Office Action Summary

10/556,802

DETAILED ACTION

*Prior Art: Matsushita Figure 6*

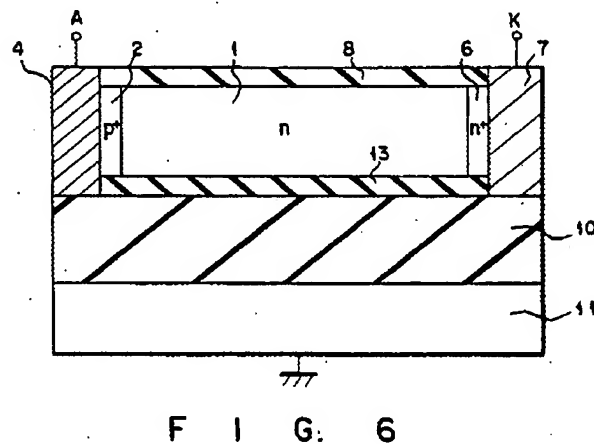
15. Per **Claim 1** Matsushita (e.g. figure 6) discloses a semiconductor device, including

- a semiconductor region having a pn junction (between n-(1) and p-(2)) and
- a field shaping region ((8) and (13)) located adjacent the pn junction,
- wherein the field shaping region ((8) and (13)) is insulating material and is coupled to first (4) and second (7) capacitive voltage coupling regions. (column 4 lines 65-69 discloses that regions (8) and (13) can be TiO_2 , which is an insulating material)

18. Per **Claims 2 and 3** Matsushita (e.g. figure 6) discloses the device of claim 1, including where the field shaping region ((8) and (13)) insulating material has a dielectric constant greater than that of both silicon dioxide and silicon nitride. Matsushita (column 4 lines 65-69) discloses that regions (8) and (13) can be “TiO₂ or BaTiO₃, or the like” which both have dielectric constants greater than that of both silicon dioxide and silicon nitride. (“Permittivity (Dielectric Constant) of Inorganic Solids” in *CRC Handbook of Chemistry and Physics, Internet Version 2007, (87th edition)*, David R. Lide, ed., Taylor and Francis, Boca Raton FL is provided as a teaching reference)

20. Per **Claim 6** Matsushita (e.g. figure 6) discloses the device of claim 1, including where the insulating field shaping region is adjacent and bridges both the p side and the n side of the pn junction. (see figure 6).

23. Per **Claim 9** Matsushita (figure 6) discloses the device of claim 1, including where at least one of the first (4) and second (7) capacitive voltage coupling regions comprises one of the p and n semiconductor regions which form the pn junction. (see figure 6).

24. Per **Claim 10** Matsushita (figure 6) discloses the device of claim 1, including where at least one of the first (4) and second ((6) and (7)) capacitive voltage coupling regions comprises a more highly doped semiconductor region (6) of the same conductivity type and adjacent one of the p and n semiconductor regions which form the pn junction. (see figure 6).
